ENVIRONMENTAL REVIEW TEAM REPORT

SHELDON CLUSTER SUBDIVISION WARREN, CONNECTICUT

OCTOBER 1979

FIGURE I. SIMPLIFIED SITE PLAN

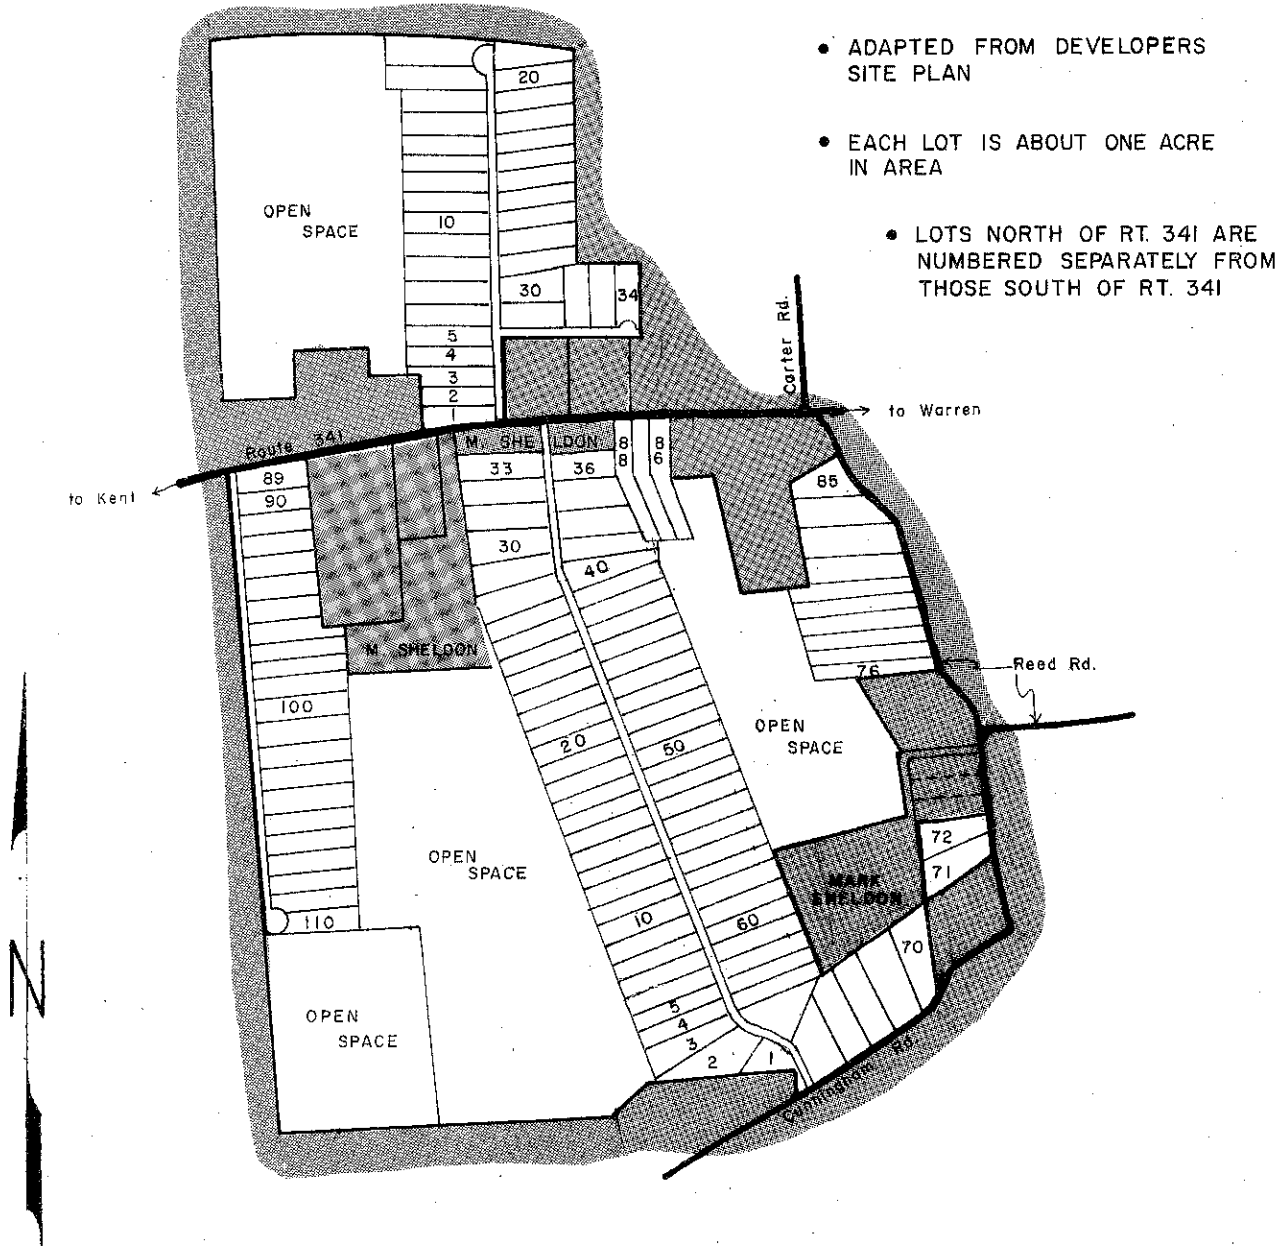
- The majority of the wetlands mapped on the property are identified as "flood hazard areas" by the Department of Housing and Urban Development Flood Hazard Boundary Maps. Although the proposed subdivision plan leaves most of these flood hazard areas as open space, it appears that lots 16-30 and lots 86-88 may infringe upon these areas.

- Area 1 (Lots 1 through 5 and 60 through 70).* This area, located off Cunningham Road, is mostly flat. Large portions appeared wet even at the time of year observed. An unmapped wetland area was pointed out by the soil conservationist for the team.

- Area 2 (Lots 71 and 72). This area is mapped as a Sutton soil which exhibits a seasonally high water table. Again slopes do not appear sufficient for effective control of any seasonally high water table by curtain drains.

- Area 3 (Lots 76 through 85). Large areas of surface water and what may have been ledge rock outcroppings were observed. On site sewage disposal does not appear feasible in this area.

- Area 4 (Lots 10 through 59). This area located to the south of Route 341, has a large portion mapped as Charlton soil series which is generally acceptable for on-site sewage disposal. However soil testing as outlined below should be conducted and would be the only appropriate judge of conditions in this area with regard to suitability for on site sewage disposal. Any layout of lots and roads should be done in consideration of soil test results.

- Area 5 (Lots 1 through 34 to the north of Route 341). Rock outcroppings and wet areas were observed throughout much of this area. Although the density of housing proposed does not appear feasible, soil testing may locate limited, adequate areas for sewage disposal and a modified proposal may be developed from test results.

- Area 6 (Lots 89 through 110). The area is mapped generally as a Hollis soil series which is shallow to bedrock. A wet area is located to the rear portion of the proposed lots. Again any proposal for development of this area should contain adequate soil testing data. Of particular concern is depth to ledge rock and provision of adequate area on each proposed lot for all required sanitary facilities (well, septic system and reserve areas).

FIGURE 4.
DESIGN POINTS AND WATERSHEDS FOR
DRAINAGE CALCULATIONS IN TEXT

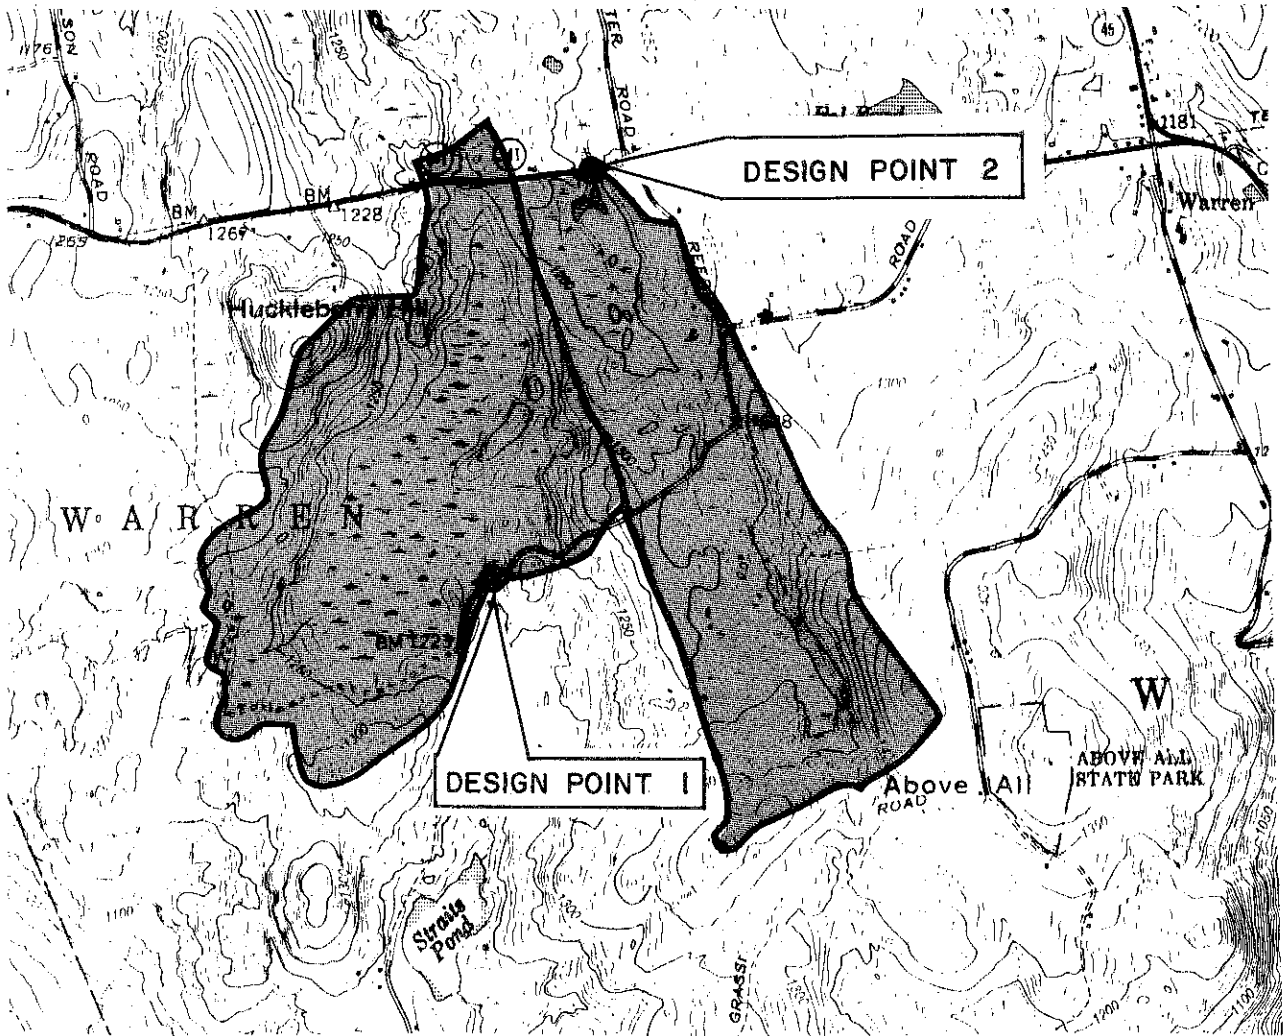
The two design points and their corresponding watersheds are shown in Figure 4. Both points chosen represent culverts through which runoff from the western and eastern sections of the property, respectively, first passes under a road. A design point was not chosen, nor runoff calculations made, for the northern section of the site. This area falls in a watershed of approximately 915 acres, of which only about 25 acres (less than 3 percent) would be developed under the current plan. Peak-flow increase from the development would therefore be insignificant in this area.

Results of the calculations for the two design points are given in Table 1. The accuracy of the flow estimates may be only "ballpark", but the calculated percentages of increase should be fairly close.

None of the above calculated peak flow increases exceeds 10 percent. The moderate level of the increases may be explained by the relatively large amount of open space that would be left following development. In addition, the peak flows listed for after-development conditions do not take into account possible piping or other channeling of runoff, which would also increase the flows to some extent.

- That a series of water quality tests be conducted at design points 1 and 2 (see Figure 4) before construction begins. These tests should be continued during construction so that if any significant increases in pollutants is observed, construction can be immediately halted until such a condition is corrected. It is suggested that the water be tested for the following: total coliform, suspended sediment, dissolved solids, specific conductance, total phosphorus, total nitrogen, and total discharge rates in cubic feet per second. The cost of such a testing program should be borne by the developer.

FIGURE 7.
DEVELOPMENT LIMITATIONS MAP II

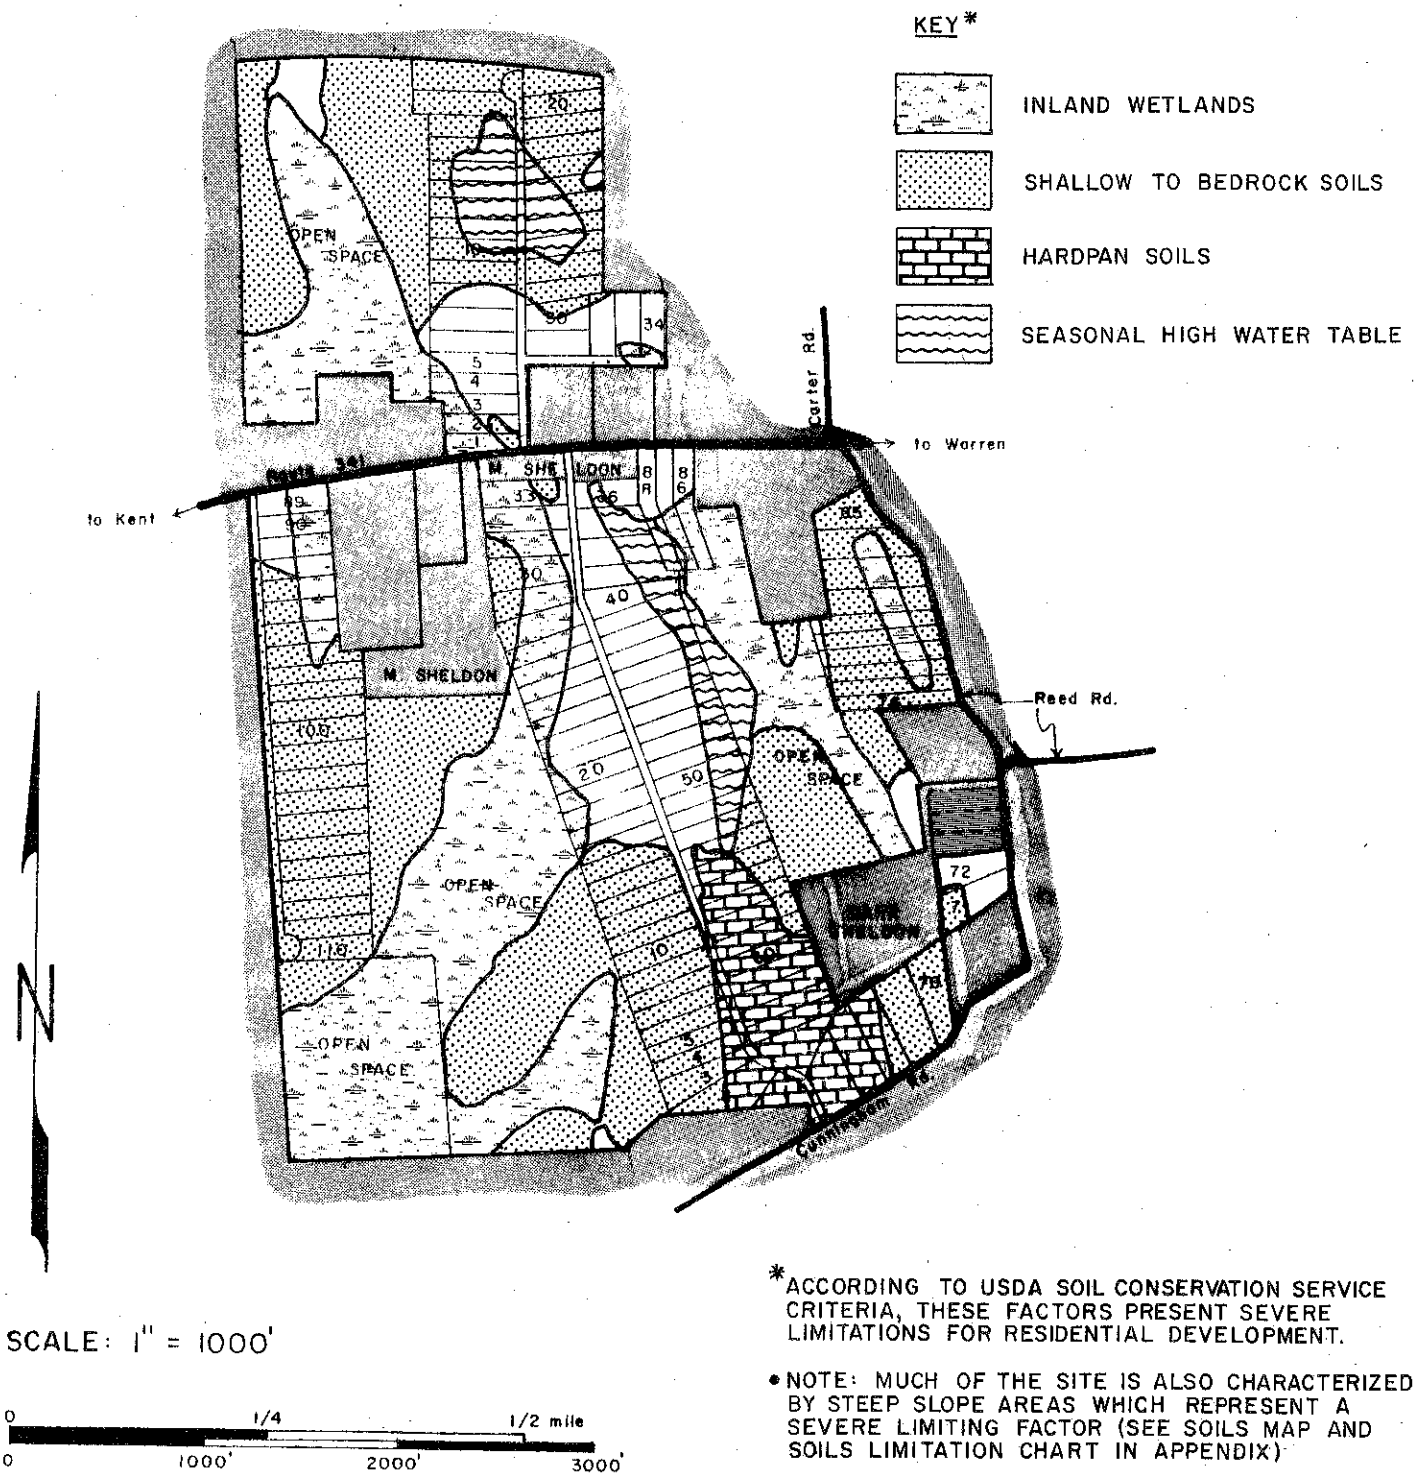
As shown in Figures 6 and 7, over 90% of the site is rated as having severe limitations for residential development according to U.S.D.A. Soil Conservation Service criteria. Many of the proposed lots are underlain by inland wetland soils, shallow to bedrock soils, hardpan soils, and areas of seasonally high water table. In addition, many of the lots are proposed in areas of steep slopes. These limiting factors may not preclude development of the property, but they do indicate that great care must be taken in developing the land to avoid significant environmental harm.

FIGURE 8.
GENERAL VEGETATION MAP

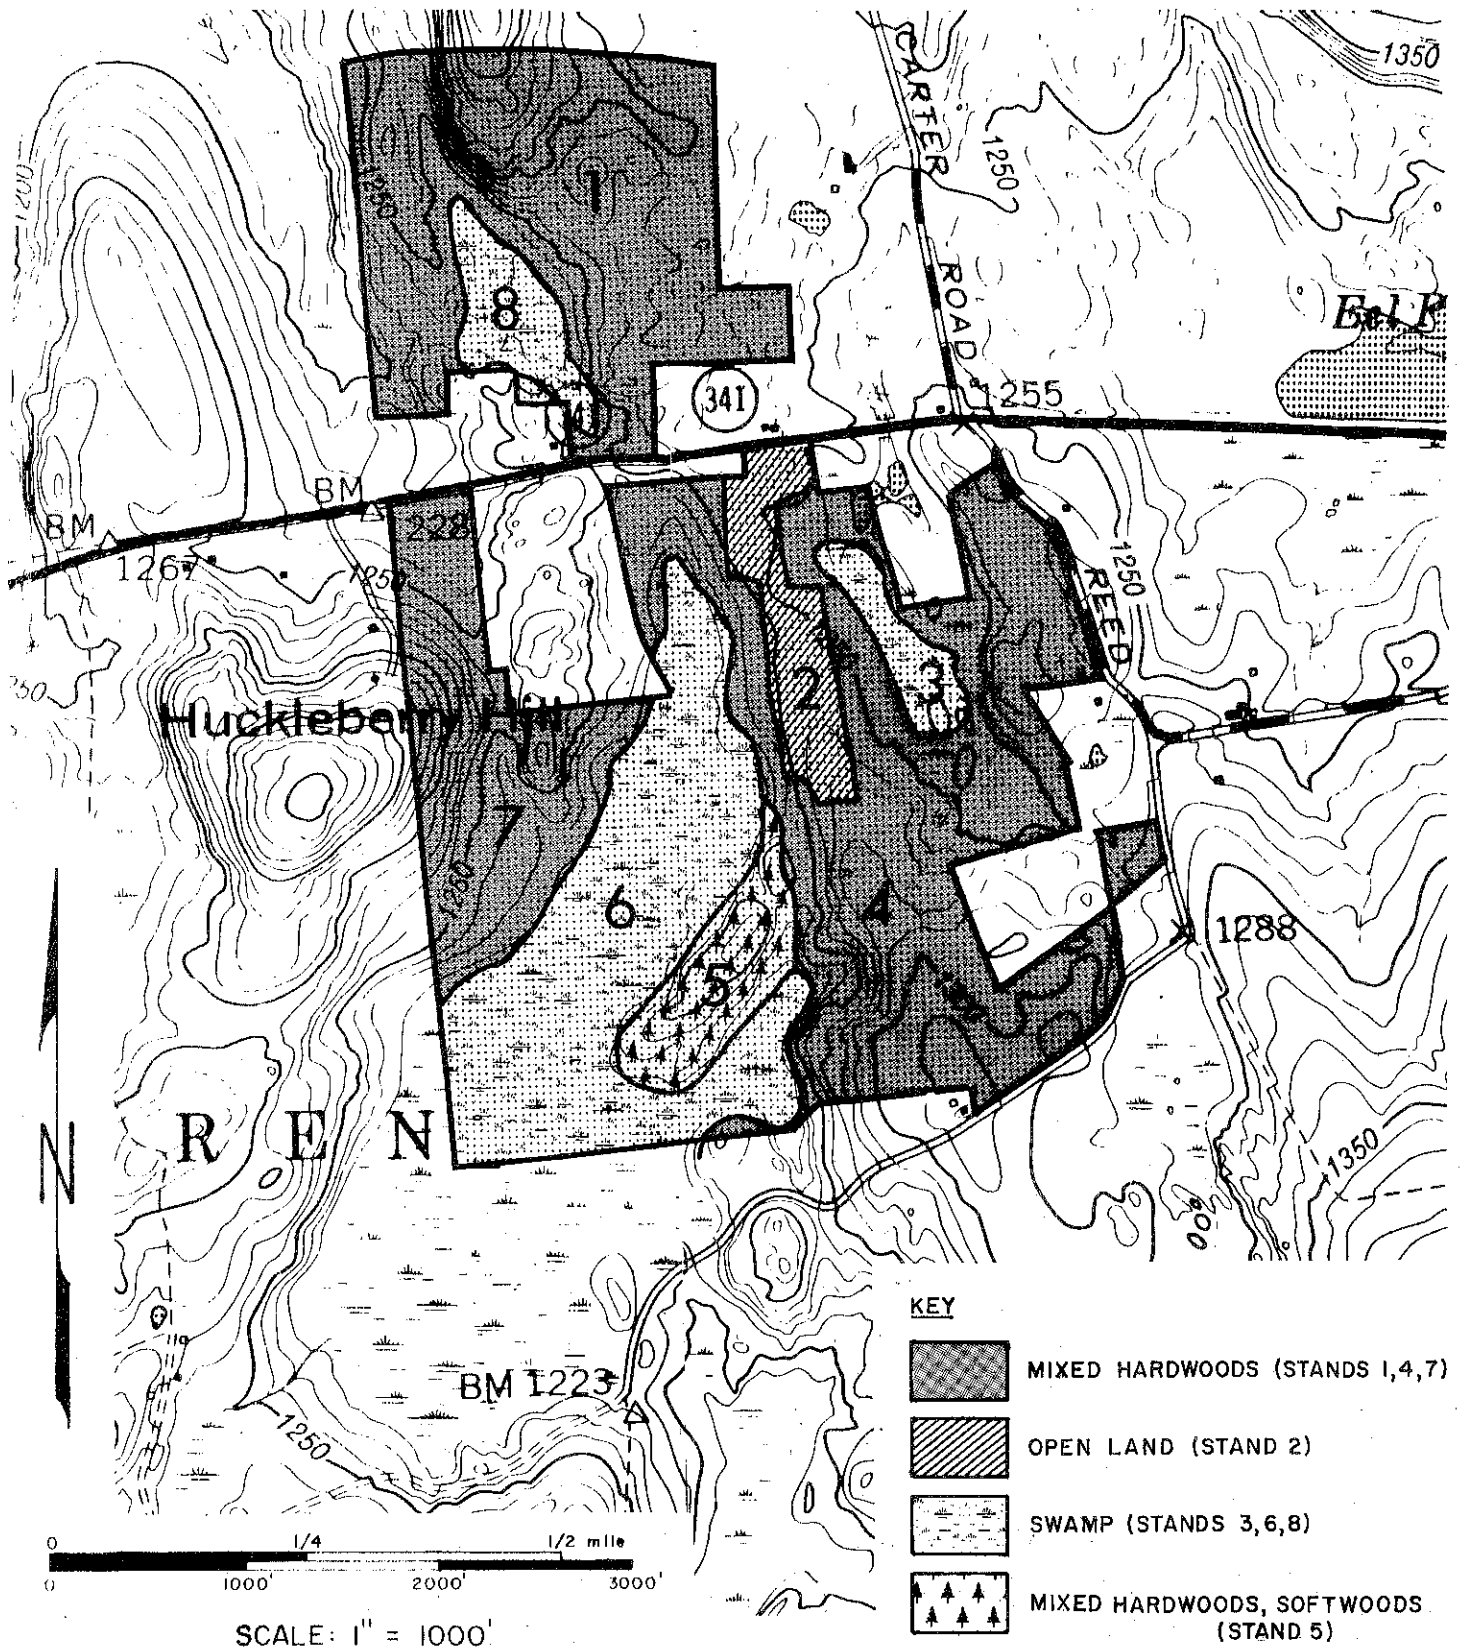
The Sheldon property may be divided into eight stands of four different vegetation types. The location of these stands and types is shown in Figure 8. A brief description of each of these vegetation types is presented below.

Along the western edge of stand 5, in close proximity to the swamp, small spruce seedlings were observed. Further investigation revealed one spruce about 10" dbh along the swamp edge. By going into the swamp some distance, a greater number of spruce seedlings were found in addition to more full grown (i.e. about 10" dbh) trees. It appears that the trees are black spruce (*Picea mariana*) rather than red spruce (*P. rubens*) which are similar in appearance. This identification was based on a twig sample and needle lengths.

The present development proposal would leave the subject area in its natural condition as "open space". This is desirable as it will serve to protect these "rare" spruce trees from direct physical injury. It is also important, however, to carefully control development uphill from the area to ensure that erosion, sedimentation, and runoff do not become a problem and represent a threat to the area.
